Brescia, 27th November 2012

IMPROVEMENT ON PRODUCT	TITANO VII 250 t
ARTICLE	TI00101 / TI00110

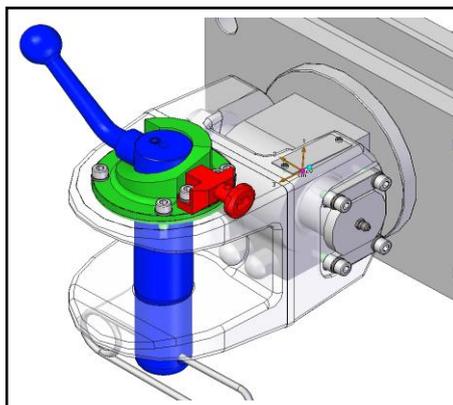
OLD PART NUMBER	RG00519
NEW PART NUMBER	RG00576
INTERCHANGEABILITY PREVIOUS MODELS	YES
AVAILABILITY	December 2012

The new kit RG00576 includes:

1. **Rotating main pin with new open lever shape (BLUE COLOURED);**
2. **Upper bush with new shape (GREEN COLOURED);**
3. **Safety device (RED COLOURED);**

The new configuration of the main coupling pin and its cam allows TITANO to work in extreme weather conditions and load, allowing the pin to rotate 360° if the poor lubrication exponentially increases the friction between the coupling pin and the drawbar eye.

The kit is fully interchangeable with TITANO previous models.

The improvement will become a standard on all new manufactured TITANO from begin 2013.
